SUNDRY NOTICES AND REPORTS ON WELLS
Do not use this form for proposals to drill or to re-enter an abandoned well. Use form 3160-3 (APD) for such proposals.

8. Well Name and No.
POKER LAKE UNIT CVX JV BS 034H

9. API Well No.
30-015-42667-00-X1

BOPCO, L.P. respectfully requests to amend the 8 pt. drilling program to include the following:
5-1/2" production casing, instead of the approved 4-1/2" open hole completions system. We will no longer run 7" casing or 4-1/2" casing. The lateral hole size will also change from a 6-1/8" lateral to a 7-7/8" lateral to accommodate casing changes.
We will also change our wellhead set up from a Cameron MBS system to a Cameron MB-NE system.
Addition of a variance to the approved APD for item #2 under VII, Drilling Section A. Drilling operations Requirements, which states the rig shall not be moved off of the hole until production casing is set. The request is to allow the rig to skid in between wellbores and drill both wells sequentially.
5-1/2", 17 ppg, HCP- 110, Buttress. Set Depth- 07-17,865'. *18,000' per directional plan*
Cement volumes- Stage 1: Lead- 450 sacks (Lead Details: 11.9 ppg, 2.26 ft³/sk yield, H₂O 12.89 gal/sk), Tail- 1,720 sack (

BOPCO
Project: South East New Mexico

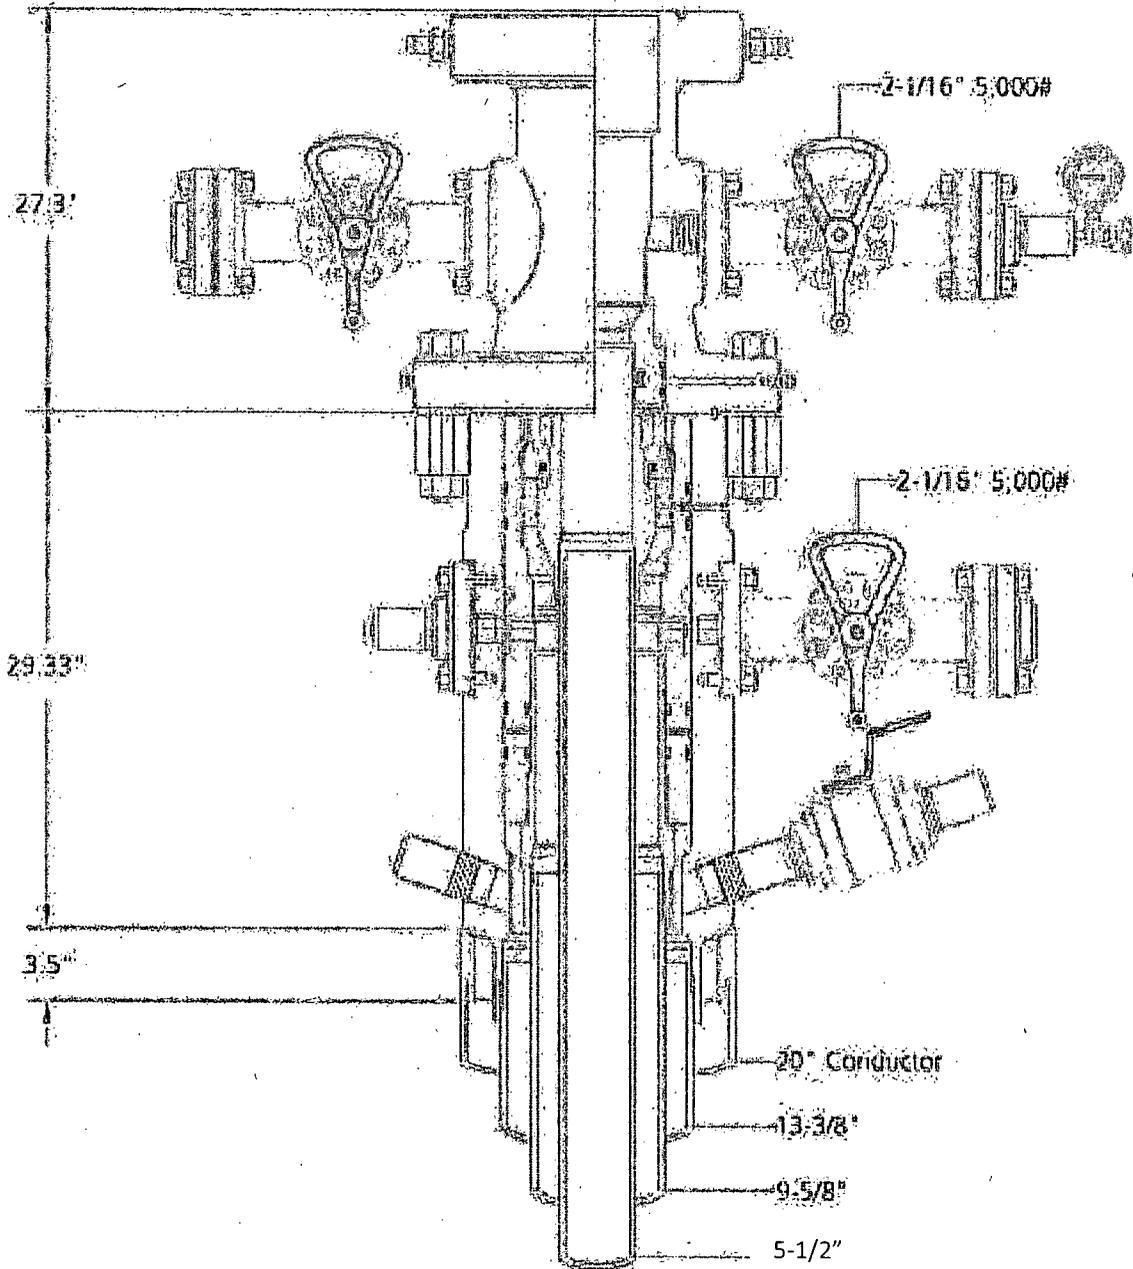
We will also change our wellhead set up from a Cameron MBS system to a Cameron MB-ND system.

3. **Operator has proposed a multi-bowl wellhead assembly. This assembly will only be tested when installed on the surface casing. Minimum working pressure of the blowout preventer (BOP) and related equipment (BOPE) required for drilling below the surface casing shoe shall be 3000 (3M) psi.**

- a. **Wellhead shall be installed by manufacturer's representatives, submit documentation with subsequent sundry.**
 - b. **If the welding is performed by a third party, the manufacturer's representative shall monitor the temperature to verify that it does not exceed the maximum temperature of the seal.**

- c. **Manufacturer representative shall install the test plug for the initial BOP test.**
 - d. **Operator shall perform the intermediate casing integrity test to 70% of the casing burst. This will test the multi-bowl seals.**
